Design & Access Statement

Section 73 application: PF/20/0756 & LA/20/0757

Erection of extension to side/rear following demolition of existing extension, external alterations including additional windows, formation of retaining wall/ raised patio to rear and re-positioning of vehicular access

9 & 10 West Raynham Road South Raynham Fakenham NR21 7HG

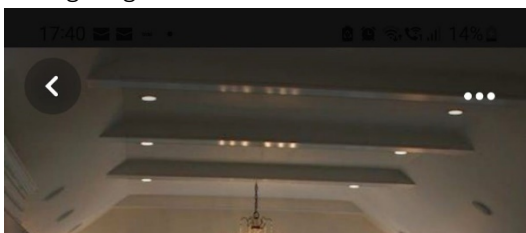
- a) The new dwelling lends itself to retaining the existing two stairs to access the first floor and for the most part the layout and fabric of the upper floor. This will ensure continuation of the use of the spaces and utilisation of existing drainage routes, there by retaining the history of the property being two dwellings and afford a more sympathetic restoration of the listed buildings.
- b) Access to the half storey basement is repositioned to the larger living room offering access to the cloak room and bedroom in the former No.10 without compromising on the use of the living room. The current head height afforded ranges from 100cm to 160cm which is insufficient headroom for safe access to the bedroom and shower room.
